CITY OF CONWAY, ARKANSAS HISTORIC DISTRICT COMMISSION

April 26, 2021 • 5:30pm • 1111 Main Street

819 Mitchell Street - New Single-Family Residence

HDC2021APR01 - Robinson Historic District

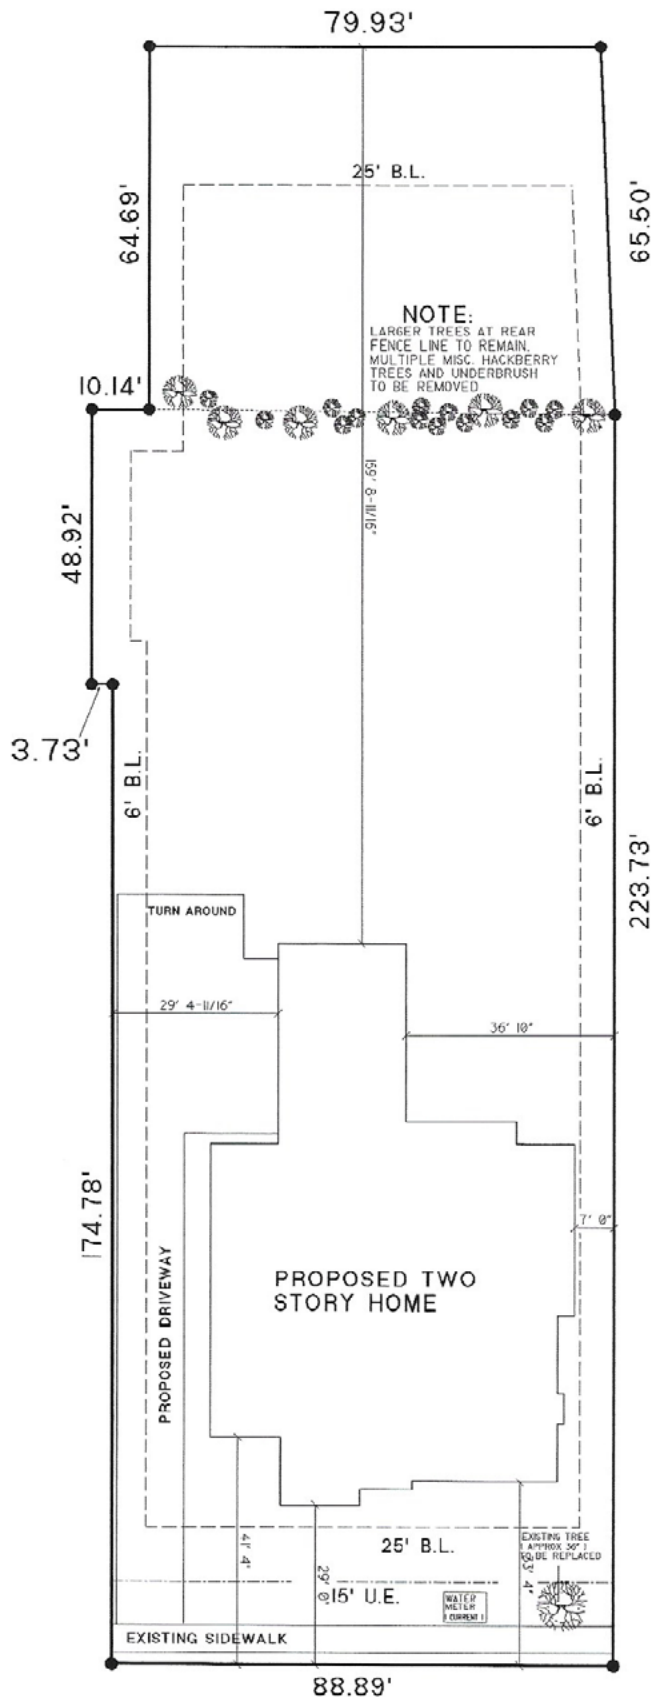
The roof form is more highly complicated than typically seen within the surrounding area or for the style, but appears appropriate.

#819 MITCHELL STREET
LOT 3 JAYS REPLAT
Leo and Lynn Crafton

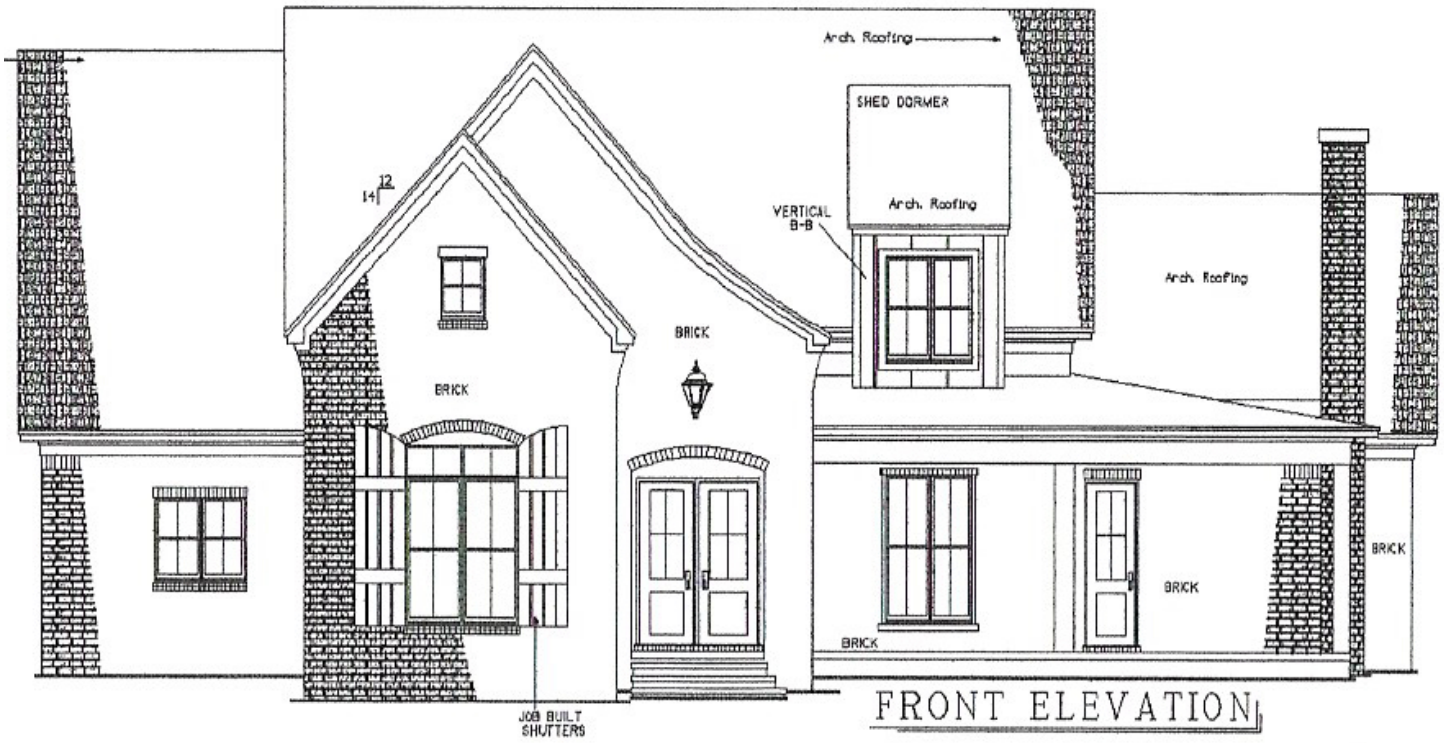
The applicant is proposing a 12' driveway along the south side of the property. The driveway's placement will place it immediately adjacent to the driveway to the south. Recommend requiring the driveway be reduced in size to match the 10' driveway to the south and moved approximately 3' to north with a 2' buffer from the house for plantings and to allow a green strip between the driveways. However, placement at the street should share the existing driveway apron or the existing driveway should be modified and reduced in size.

The proposed structure will contain far fewer window openings compared to surrounding structures. Window openings are highly prominent for all surrounding structures. However, the deep covered porch will help reduce the visual impact of this.

Recommend requiring at least 25% of the front and side façades (excluding the garage area) be composed of window openings. This would include the addition of a window along the front façade on the north side of the structure. This would also include additional windows along the side façades including an opening in the alcove on the north side façade.

The front entry appears appropriately substantial for the area. Windows will require true divided lights. The addition of shutters is not consistent throughout the structure and appear very conjectural. Recommend requiring removal of the shutters.

1. Require planting of 3 understory trees in the front yard.
2. Require the driveway be reduced to 10' and moved approximately 3' to the north with a 2' buffer from the house for plantings. However, placement at the street should share the existing driveway apron or the existing driveway should be modified and reduced in size.

3. Require at least 25% of the front and side façades (excluding the garage area) be composed of window openings. Including the addition of a window along the front façade on the north side of the structure, and additional windows along the side façades including an opening in the alcove on the north side façade.

4. Require true divided light wooden windows.
5. Require fascia and soffits to be finished with wood or Hardieboard construction.
6. Any fencing will require HDC approval.

Existing staircase to be removed

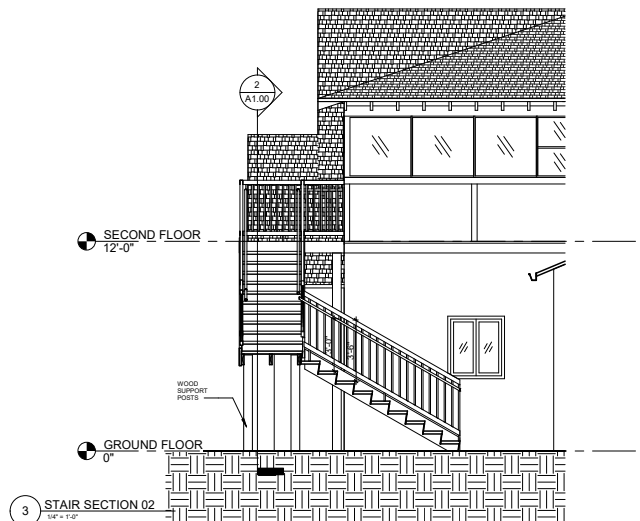
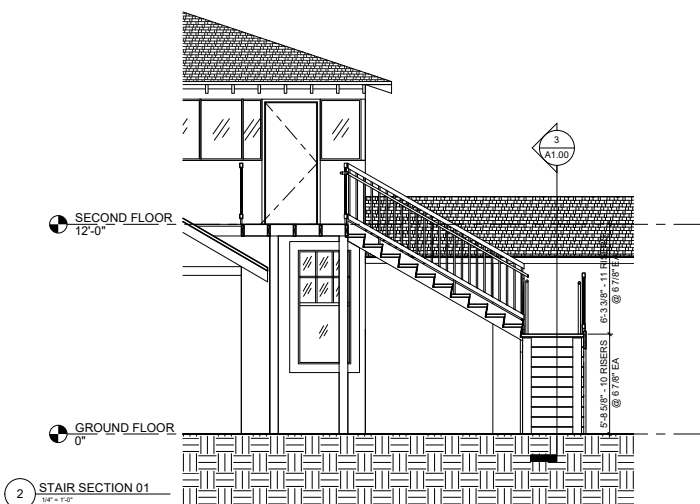
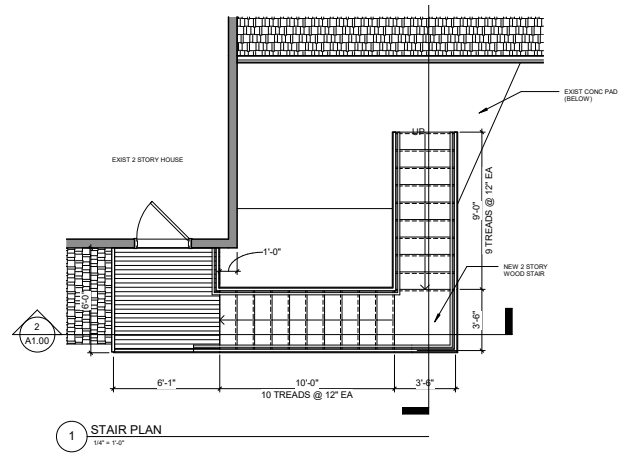
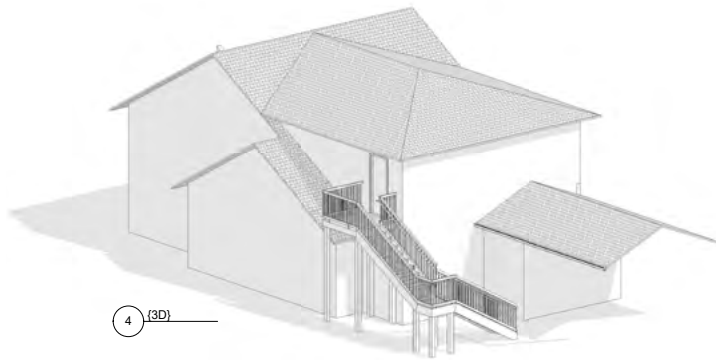
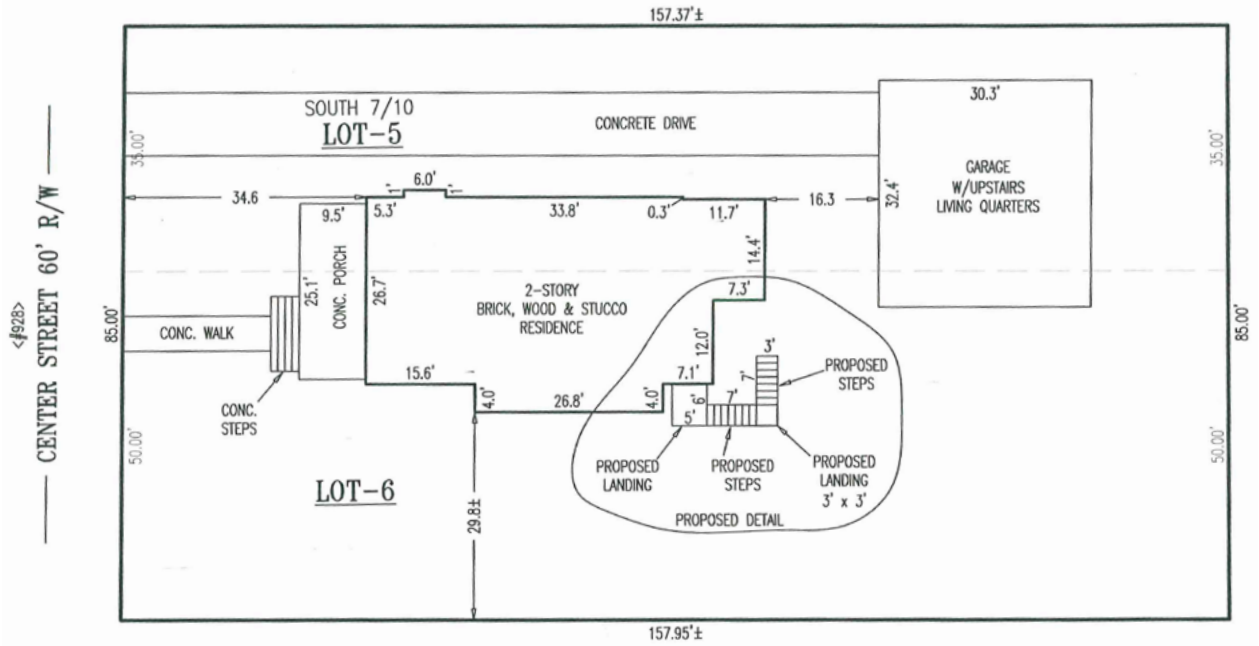
The proposed replacement staircase and railing are located at the rear of the structure and do not represent an exact match of what would have been historically placed on the structure. This approach is appropriate to the structure such that it helps denote that it is not an historic element on the home. The majority of the staircase is not visible from the public right-of-way therefore the proposal is appropriate.

Though not proposed, Staff recommends prohibiting the addition of lattice or similar screening to staircase structure or railing, as it is present on the existing staircase.

1. The use of lattice or similar screening material is prohibited.

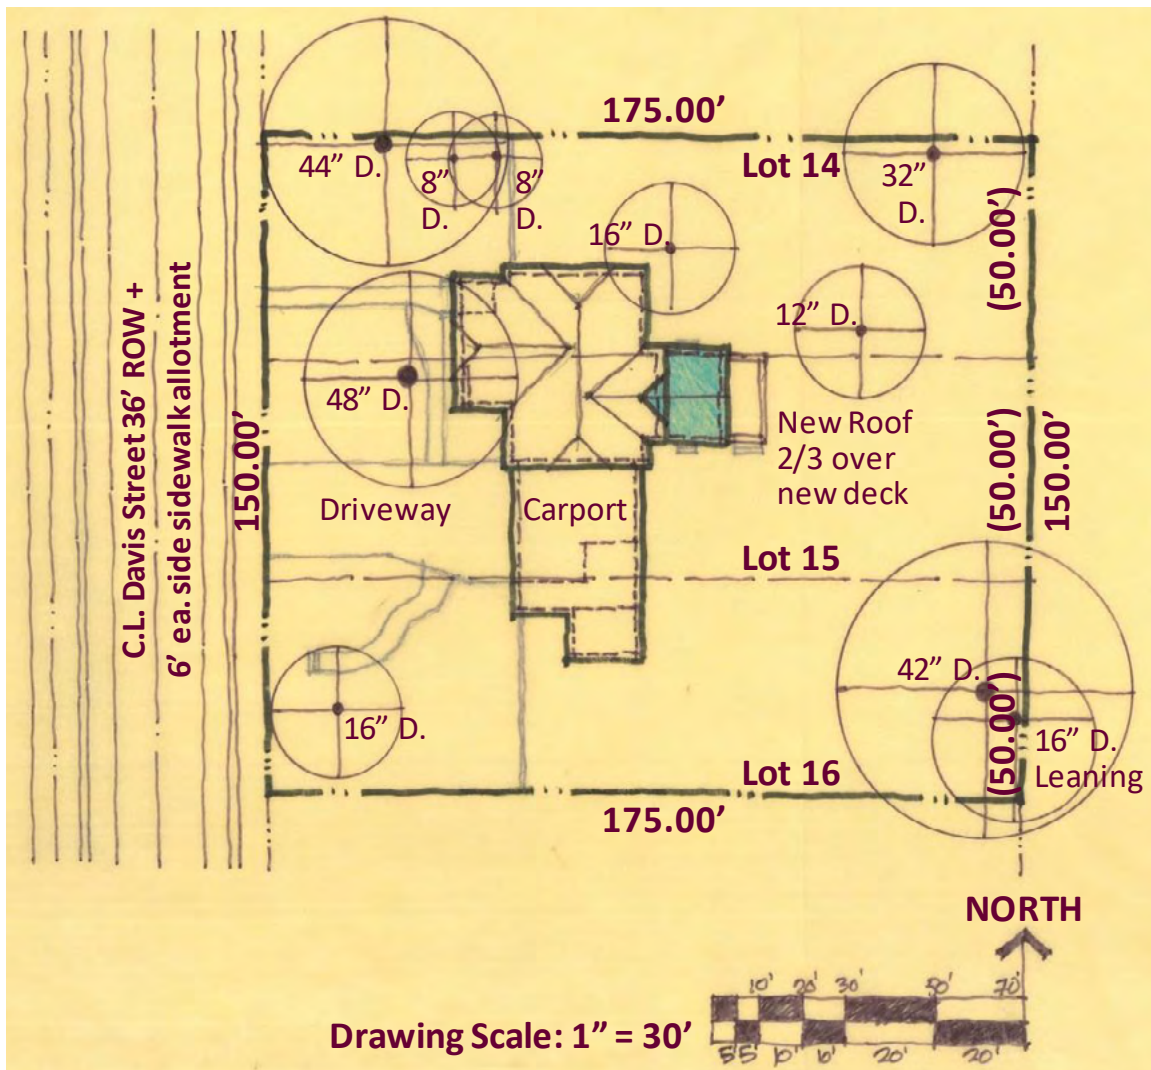
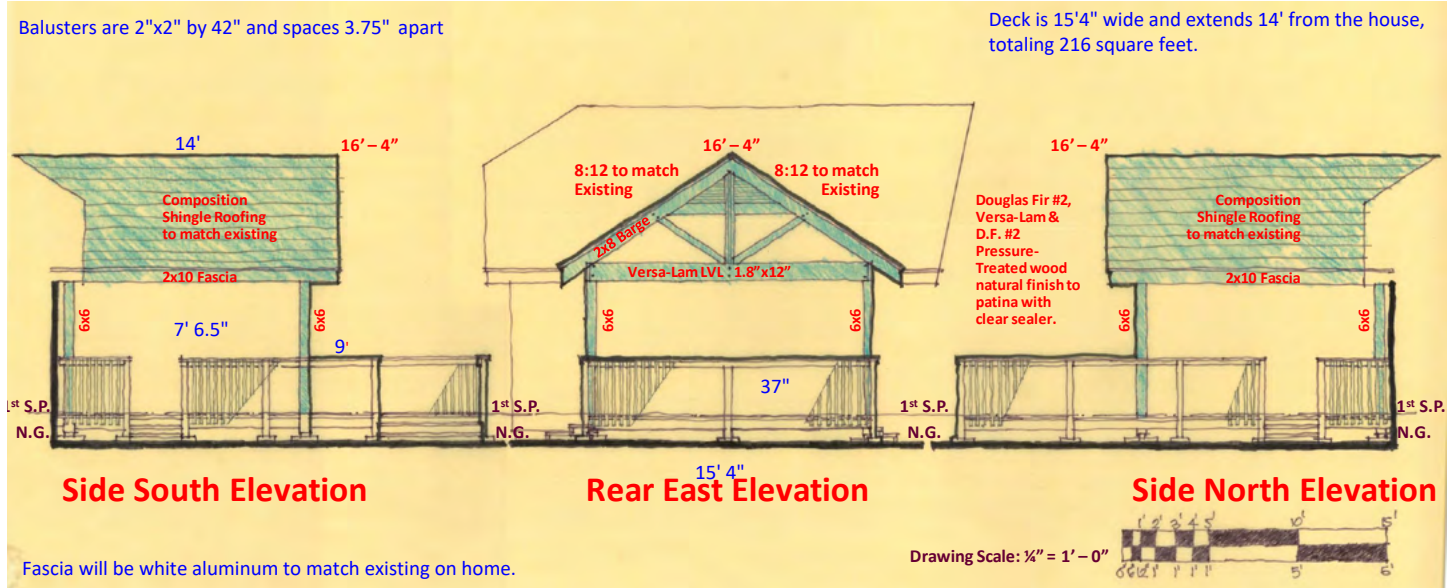
The alteration will be a conjectural element added on to the house, however, there is precedent for covered decks. To maintain consistency in design, wide trim matching existing style of window trim on the opening should be used to surround the overall opening for the new entry.

The proposed covered deck on the rear elevation will match the existing pitch of the roof with matching shingles. The end gable will include a contemporary design to help distinguish it from the existing structure.

The applicant is proposing to construct the deck at the rear of the structure within a fenced and wooded yard.

1. Require the structure be constructed with detailing as submitted.
2. The addition and all work must fully comply with all Building Codes.

New Porch
for
Dan and Cindy Williams
619 Mitchell Street
Conway, Arkansas

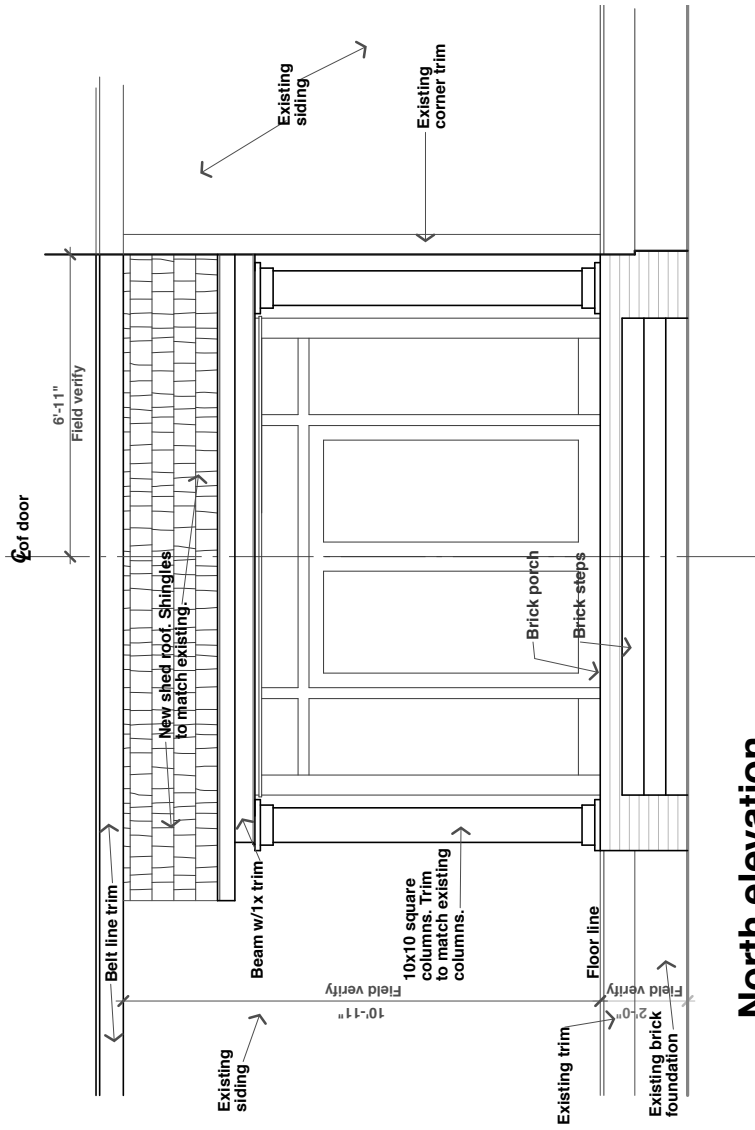
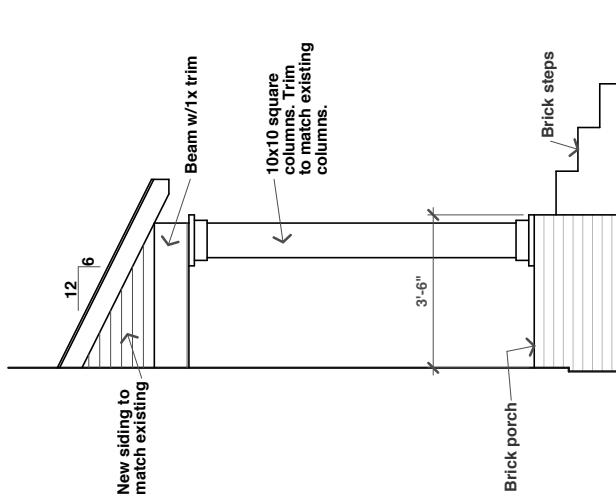
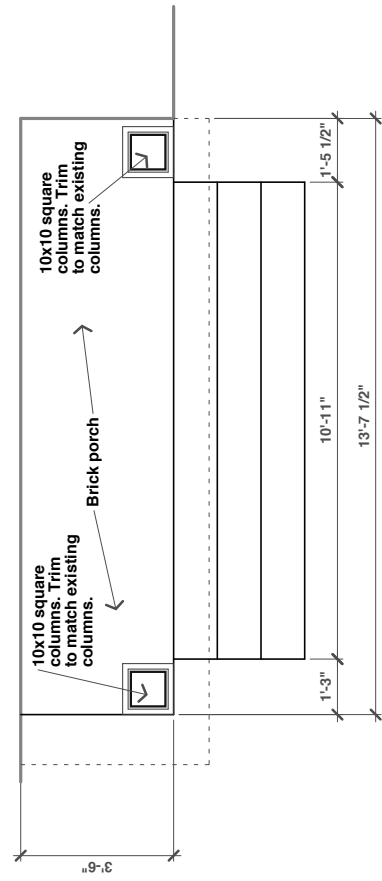
The landing for the entry will use, in part, brick salvaged from repair of the chimney plus brick to match. Entry landing is proposed to be covered and will feature 10"x10" square columns with trim to match existing front porch columns.

No railing is proposed. Staff recommends if railings are added they should match the front porch in style and construction.

1. If railings for the entry are added they should match the front porch in style and construction.
